REVIEW OF INCONSISTENCIES BETWEEN SUDAS AND IOWA DOT SPECIFICATIONS

Project Number: TR-524

Project Synopsis

Example cover page from Standard Road Plan and SUDAS Figure Review:

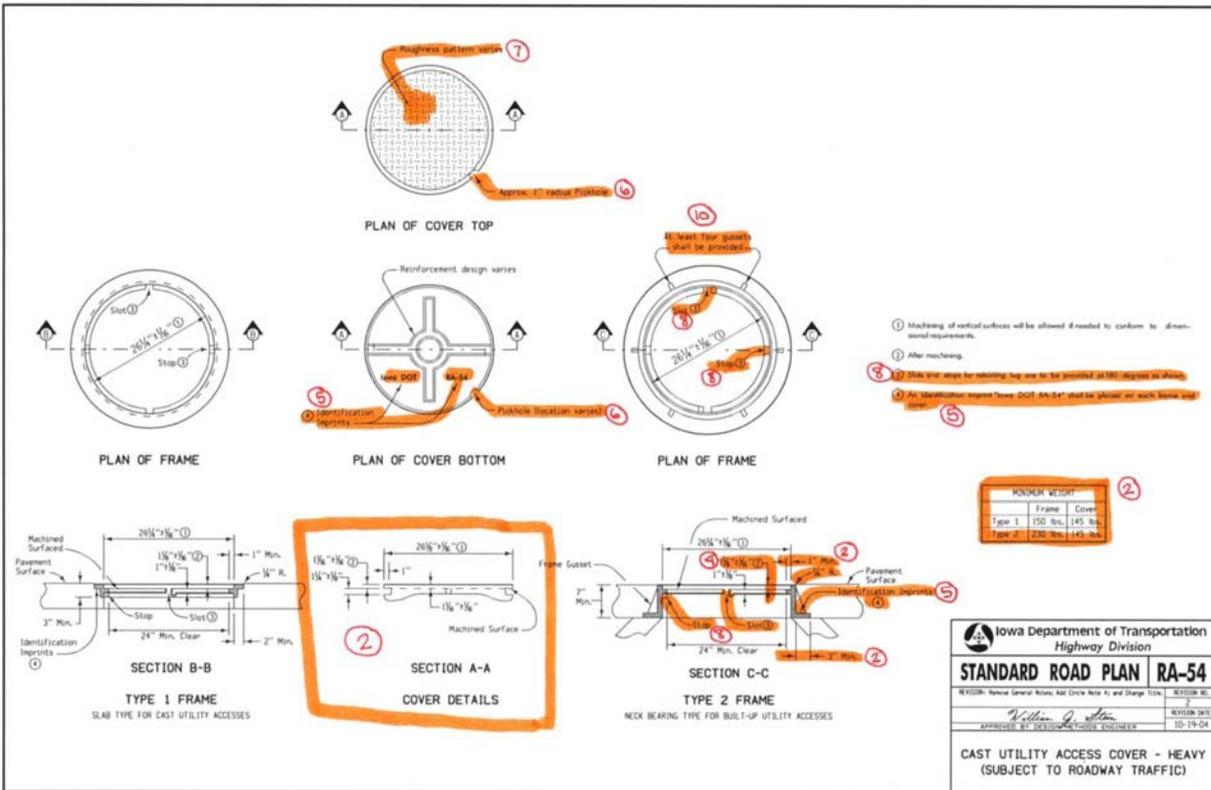
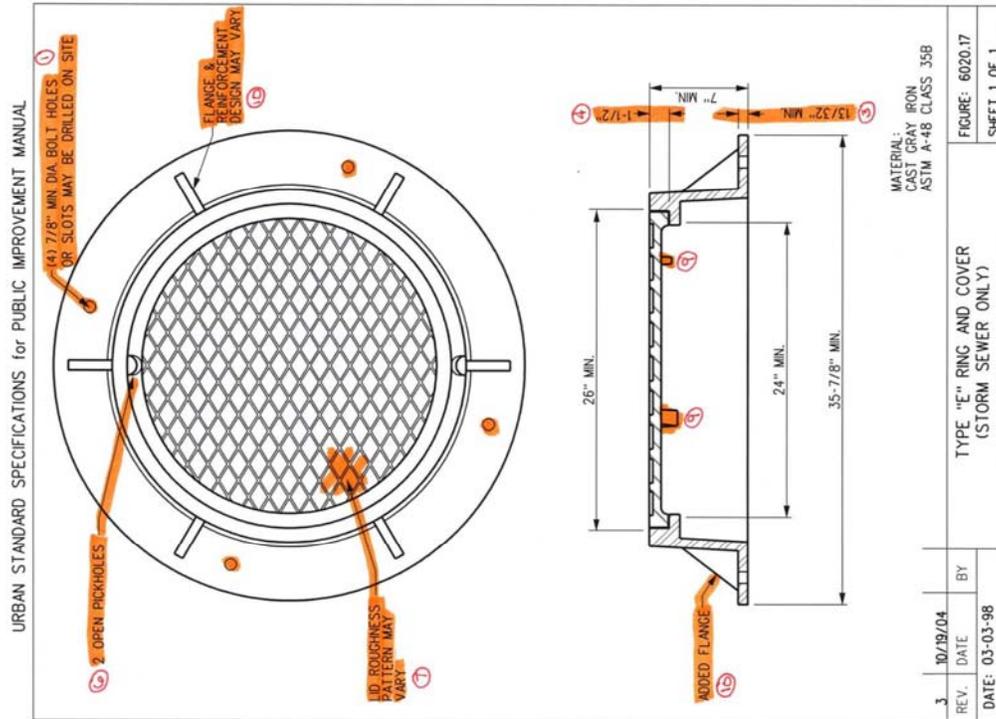
GENERAL: SUDAS detail is specifically for sanitary sewer. DOT detail does not specify if it's for sanitary or storm sewer, although it is assumed that it applies to both. SUDAS detail is only equivalent to DOT Section C-C (Type 2 Frame).

1. SUDAS detail shows bolt holes around the edge of the rim. DOT does not.
2. SUDAS detail shows gasket seal, DOT does not.
3. DOT detail gives more specific information concerning: dimensions of various portions of the frame, frame and cover weights, machining tolerances, specific shaping and dimensions on lid.
4. DOT requires that the frame and lid be marked to indicate what type they are. SUDAS does not.
5. DOT shows one pick hole. SUDAS detail shows two pick holes. DOT gives a size for the pick hole, SUDAS does not.
6. Both details show a different pattern on the top of the lid, although they both indicate that the pattern will vary.
7. DOT lid shows location of slots and stops. SUDAS detail does not mention slots or stops.
8. SUDAS detail has odd, unlabeled bumps showing on the bottom of the lid in side view.

- SUDAS beef up the detail to include more dimensions and detail views.
- DOT and SUDAS coordinate precise dimensions of frame and lid.
